TÜRK LOYDU RULE CHANGE SUMMARY

TL NUMBER: 03/2017

JULY 2017

RULE CHANGE SUMMARY

Figure 10.6 Location of CTOD test specimens for chain

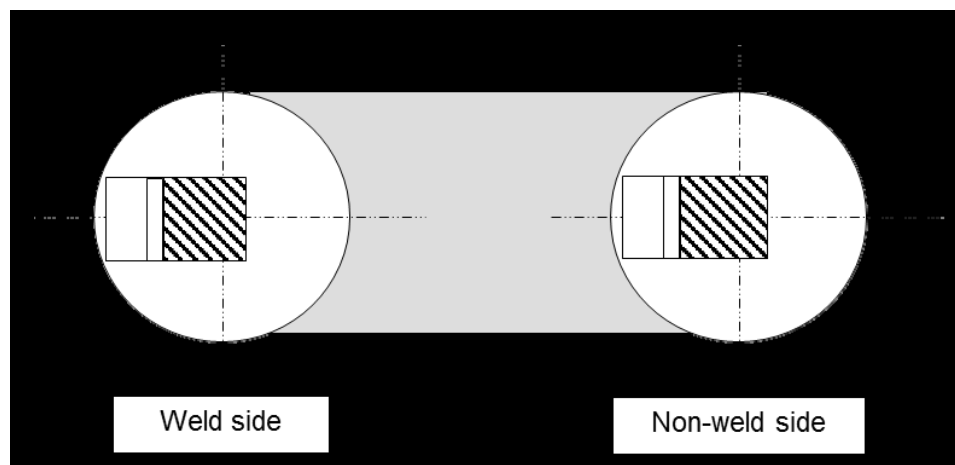
1.3.3 For initial approval CTOD (Crack Tip Opening Displacement) tests are to be carried out on the particular IACS mooring grade of material. CTOD tests are to be tested in accordance with a recognized Standard such as BS 7448 Part 1 and BS EN ISO 15653:2010. The CTOD test piece is to be a standard 2 x 1 single edge notched bend piece, test location as shown in Figure 10.6. The notch of the CTOD specimen is to be located as close to the surface as practicable. The minimum cross section of the test piece shall be 50 x 25mm for chain diameters less than 120 mm, and 80 x 40 mm for diameters 120 mm and above. CTOD specimens are to be taken from both the

side of the link containing the weld and from the opposite side. Three links are to be selected for testing, a total of six CTOD specimens. The tests are to be taken at minus 20°C and the lowest CTOD of each set of 3 specimens shall meet the minimum values indicated below, Table 10.15

Figure 10.7 Location of CTOD test specimens: a) Circular type accessory and b) rectangular type accessory, B corresponds to the thickness of material, the grain flow is considered in the longitudinal direction X

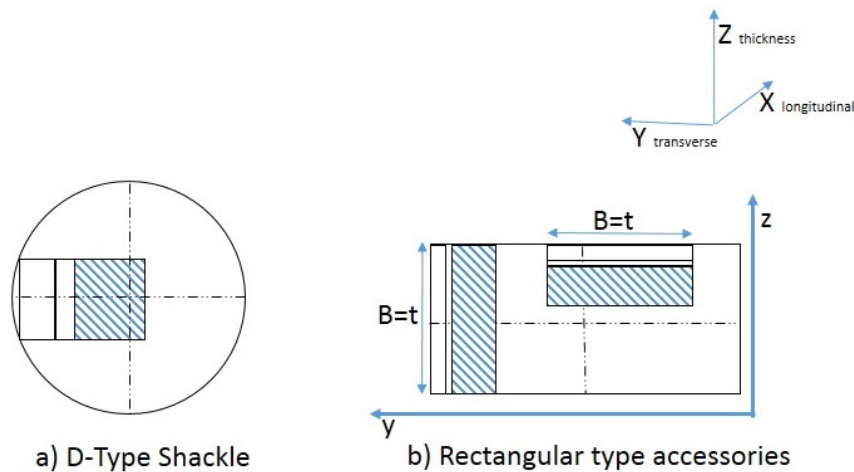
The geometry of accessories can vary. Figure 10.7 shows the CTOD location for circular and rectangular cross sections such as those of the D-shackle and accessories fabricated from rectangular sections. The orientation of the specimen shall consider the direction of the grain flow. Figure 10.7(b) shows two possible sampling positions for CTOD test specimens with notch orientation for rectangular type accessories.

New Figure 10.7 is added as below and following figures are renumbered:

Figure 5.23

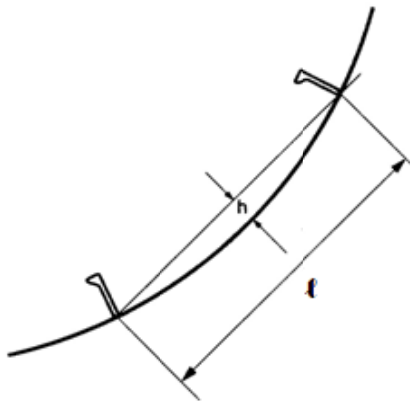
Item K_2 explanation at E.3 is revised as below:

K_2 = Curvature correction factor given by $1 - h / \ell$ where h is the maximum curvature height (see Figure 5.23). This value is to be taken not less than 0,75.

Figure 6.2

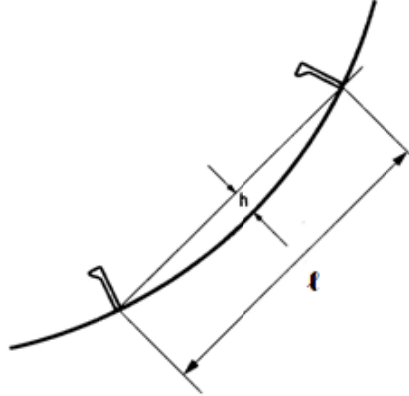
Item K_2 explanation at F.3 is revised as below:

k_2 = Curvature correction factor given by $1-h/\ell$ to be taken not less than 0,75, where h is the distance measured perpendicularly from the chord ℓ to the highest point of the arc of plating between the two supports (see Figure 6.2).
